# Summit Apartments

1728 Summit Avenue

## DESIGN REVIEW RECOMMENDATION - MEETING 2

MARCH 27, 2013

# DESIGN RESPONSE: MASSING & SUMMIT FACADE

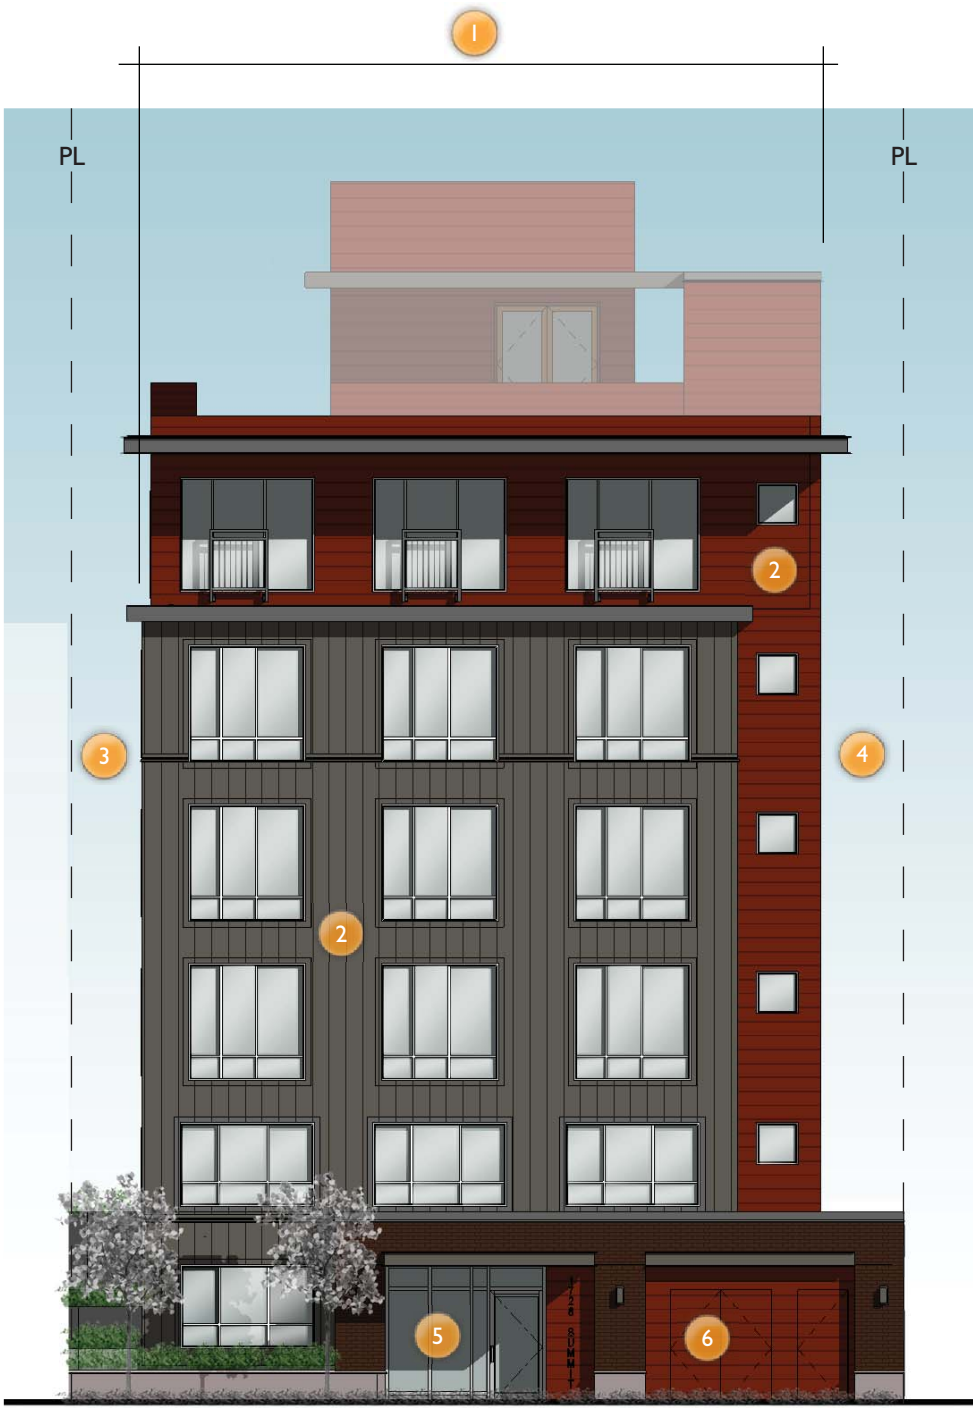
At EDG the Applicant proposed a zero lot line condition with no setbacks provided at the north property line to alleviate the blank wall conditions of the neighboring building. At DRB, commentary evolved to note that setbacks adjacent to freestanding towers were more prevalent in the neighborhood and that the design needed to better respond to that observation. Other design elements common in the neighborhood but lacking in the current design were facade designs composed of 3 bay width patterns, bay window projections, and recessed and/or accented building entries. Many buildings front directly on the back of sidewalk and/or propertyline, and virtually all have refuse / recycling collection and storage either in the rear of the building off an alley or in front or immediately alongside the streetfront facade of Summit Avenue.

The Board went on to reinforce simplicity and continuity in the facade designs and exterior materials. Privacy should be maximized between properties through careful placement of glazing. In particular, the front facade should be more limited in siding types and more continuous to better reflect neighborhood patterns.

In response to Board comments, the proposed building was reconfigured both at the street level and pedestrian scale as well as in the tower massing. The primary building modulation and massing were revised to provide setbacks at both north and south facades to mimic neighborhood context by consolidating the front massing into a 3-bay composition to reflect neighborhood character. Increased upper level setbacks as requested by the Board were provided by setting the top story and secondary building massing back approximately 18" from the front mass and adding a dramatic overhang to reinforce the building's skyline. The primary massing was then brought down to grade to match the neighborhood pattern of buildings with strong continuous edges from ground level to roof. Due to the utility line clearances required by Seattle City Light (SCL), no projections towards the street were permissible, so the primary modulation was treated as one large bay window. To emphasize the continuity of the common facade material and detailing, the mass wraps the south face 18" back to the next modulation facade while the north wrap extends down the north facade.

The rear (east) setback of 15 feet is now provided. A ground level open space with private patios connected to units is present for enjoyment to all residents. No departures are requested at this area in the current proposal. The reduction in project envelope here in conjunction with responding to the DRB comments about pulling away the north facades from the north property line necessitated a reconfiguration to minimize loss of residential units. The result was a mid-facade modulation on both the north and south facades but also the loss of the open air courtyard facing northward as originally presented in DRB #1.

STREET LEVEL FACADE PERSPECTIVE

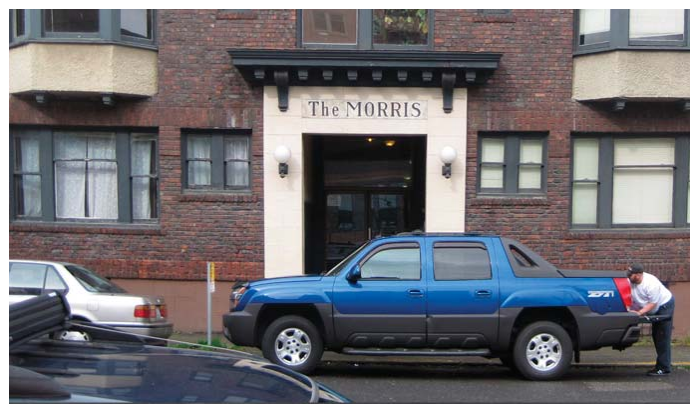
The Board indicated in their last review that the street level facade needed a number of refinements, including strong establishment of the ground level materials and treatments (i.e. base, body, cap, shadow, etc), attention to entry location and sequence, and treatment / operation of refuse / recycling storage and collection areas. Additional refinement of landscaping between the street / sidewalk and the proposed building also would reinforce (or diminish) the quality and character of the project. Use of human-scaled materials would improve architectural character.

In response to other Board comments related to providing setbacks at the north property line, the street-level facade and adjoining uses were reconfigured as part of internal building reconfiguration. The primary massing with continuous exterior materials now solidly grounds at a new landscape planter which turns the corner eastward, reinforcing the newly created setback at the pedestrian level. The planter extends to the new residential entry location, now housed in a residential podium of brick and precast concrete which mimics adjacent and neighborhood buildings. This podium is also recessed backwards from the sidewalk from the prior design, now allowing more landscaping at ground level as well as allowing the refuse / recycle room access to reverse door swing and mitigate wear and tear on building elements. The refuse / recycle room doors remain concealed in matching panel siding to retain emphasis on the residential entry from the street.

PLAN OF PRIOR DESIGN PROPOSAL - DRB MTG #1

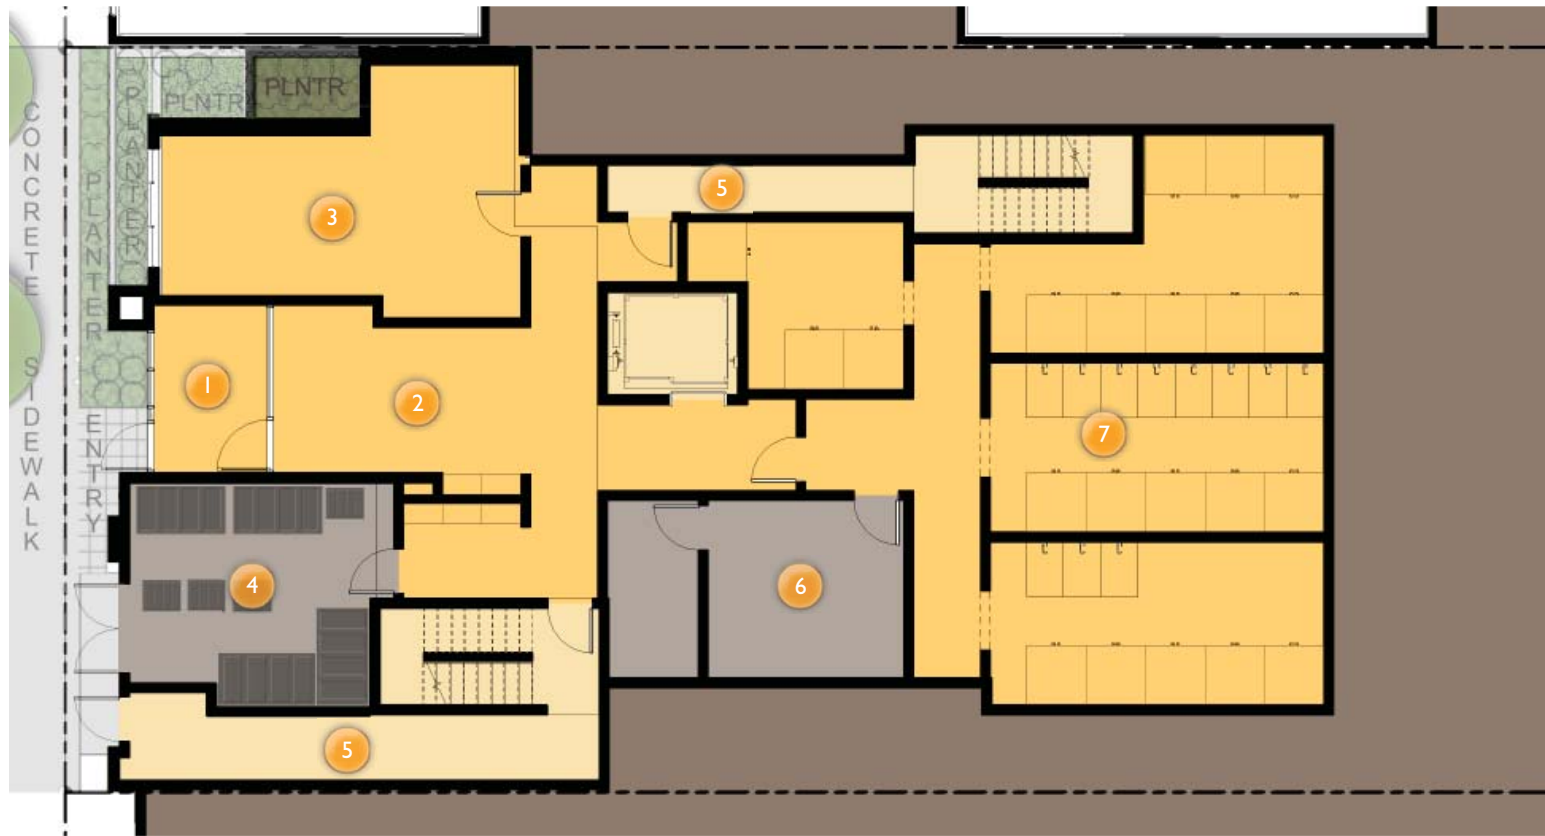
The Board had a strong response to the prior design which requested a reduced rear (east) setback and denied the departure request for the project as designed. The Board further requested that the Applicant pursue a code-compliant design in this area of the site due to substantially sub-standard setbacks of adjacent neighboring buildings in order to increase light and air for all residents. The Board also responded both to public comment and internal discussions and reversed course on the prior design's treatment of the large neighboring building's blank walls by creating a non-conforming zero-lot line condition to mitigate the blank walls themselves. This response in combination with the desire for massing and setbacks to better respond to contextual patterns such as common setbacks on all sides of buildings essentially requires the Applicant to revise their project substantially in order to progress.

Based on the feedback received from the Board the building was completely redesigned to remove all development within the rear setback and to accommodate the new side setbacks at the north property line. This included reconfiguration of the internal circulation, relocation of the stairs and elevator as well as unit placement. As shown in the development summary, both gross building area and almost 20% of the residential units were removed to accommodate this change.

As a result of the reconfiguration, no rear setback departure is requested with the modified scheme.

In order to maintain modulation, minimizing blank walls as well as preserving project viability, it was necessary at the north property line to provide a minimum 5' setback (4'-6" where the street facade materials return the corner as shown) and the modest courtyard in the prior design was replaced by modulation. Departures are still required in this area but their extent is reduced.

As a part of the building's reconfiguration in response to the north and east setbacks, as well as maintain modulation, minimize blank walls as well as preserving project viability, it was necessary to provide a minimum 5' setback. Departures are still required in this area but their extent is reduced.

# DEPARTURE REQUESTS: SOUTH SETBACKS

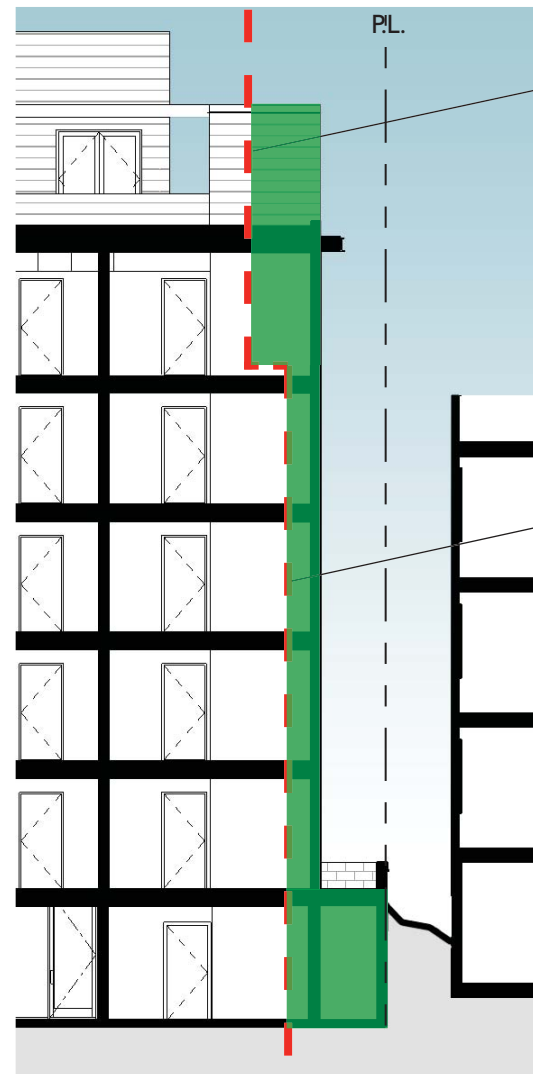
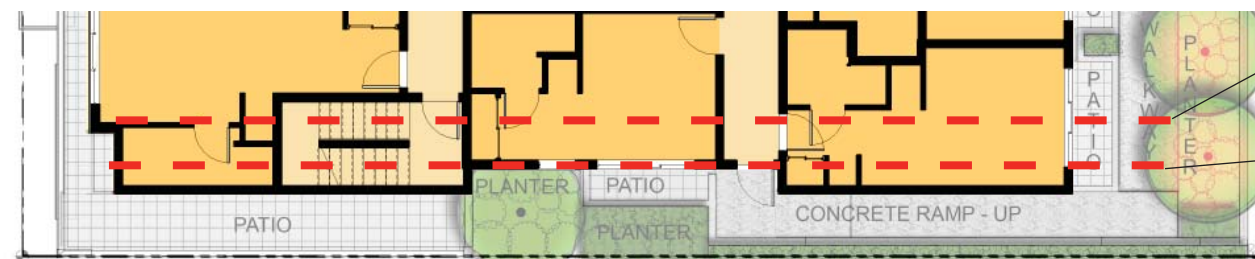
| 2 | D2 | SMC 23.45.518<br>DRB #1 BOARD RESPONSE:<br>FAVORABLE | SIDE SETBACK - S. BLW 42' | 7' Average setback required with a min. of 5' from +0' to +42' above grade.           | Reduce required setback to:<br>Minimum = 0'-0" (SW corner only)<br>Maximum 7'-0"<br>Average = 3.58' | Ground level street front facade at west extends to property line at south to establish podium for building. Zero setback at south only exists for short distance before floor 1 facade is underground. Tower above is a minimum of 5' of setback at all levels 2 and above and further is modulated mid-building to provide visual and massing relief as well as maximizing light and air. Building modulation limited to horizontal adjustments in plan in response to neighborhood patterns. Location of building on property in response to creating north setback necessitated reducing south setbacks. Departures requested are minimum possible while maintaining minimum building code requirements. |
| 3 | D3 | SMC 23.45.518<br>DRB #1 BOARD RESPONSE:<br>FAVORABLE | SIDE SETBACK - S. ABV 42' | 10' Average setback required with a min. of 5' from +42' to height limit above grade. | Reduce required setback to:<br>Minimum = 5'-0"<br>Maximum = 7'-0"<br>Average = 6.51'                |  |

PUBLIC BENEFIT: DEPARTURE ALLOWS FOR THE VERTICAL CONSISTENCY SEEN ELSEWHERE IN THE NEIGHBORHOOD BY MAINTAINING A PLANER FACADE

PUBLIC BENEFIT: SLIGHTLY WIDER BASE ALLOWS FOR THE BUILDING TO BE A STORY SHORTER TO BETTER MATCH THE HEIGHT OF THE NEIGHBORHOOD. BUILDING WIDTH IS SIMILAR TO ADJACENT PROJECTS WITH THIS DEPARTURE.

# DEPARTURE REQUESTS: NORTH SETBACKS

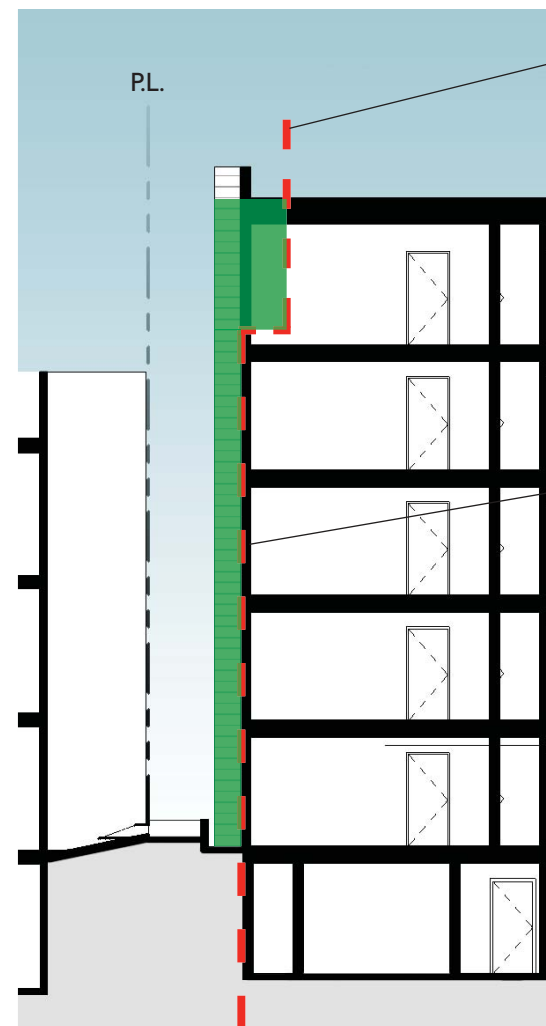
| 4 | D4<br>DRB #1 BOARD RESPONSE:<br>FAVORABLE IF REVISED | SMC 23.45.518<br>SIDE SETBACK - N. BLW 42' | 7' Average setback required with a min. of 5' from +0' to +42' above grade.           | Reduce required setback to:<br>Minimum = 4'-6" (front section only)<br>Maximum = 7'-0"<br>Average = 5.51' | The design was moved back from the property line to create setbacks more architecturally contextual to the neighborhood. This gesture was made but full zoning conformance was not practically feasible. In compensation, the ground level street front facade at north is recessed to provide landscaping around base of residential tower above to reinforce setback to neighboring building. Tower above is a minimum of 5' of setback at all levels 2 and above and further is modulated mid-building to provide visual and massing relief as well as maximizing light and air, with one exception. In response to DRB comments, the exterior siding of the primary east facade are uniformly continued around the north facade, thus reducing the setback to approximately 4'-6" for a limited distance. Building modulation limited to horizontal adjustments in plan in response to neighborhood patterns. Location of building on property in response to creating north setback necessitated reducing south setbacks. Departures requested are minimum possible while maintaining minimum building code requirements. |
| 5 | D5<br>DRB #1 BOARD RESPONSE:<br>FAVORABLE IF REVISED | SMC 23.45.518<br>SIDE SETBACK - N. ABV 42' | 10' Average setback required with a min. of 5' from +42' to height limit above grade. | Reduce required setback to:<br>Minimum = 4'-6"<br>Maximum = 7'-0"<br>Average = 5.63'                      |  |

PUBLIC BENEFIT: DEPARTURE ALLOWS FOR THE VERTICAL CONSISTENCY SEEN ELSEWHERE IN THE NEIGHBORHOOD BY MAINTAINING A PLANER FACADE

PUBLIC BENEFIT: SLIGHTLY WIDER BASE ALLOWS FOR THE BUILDING TO BE A STORY SHORTER TO BETTER MATCH THE HEIGHT OF THE NEIGHBORHOOD. BUILDING WIDTH IS SIMILAR TO ADJACENT PROJECTS WITH THIS DEPARTURE.
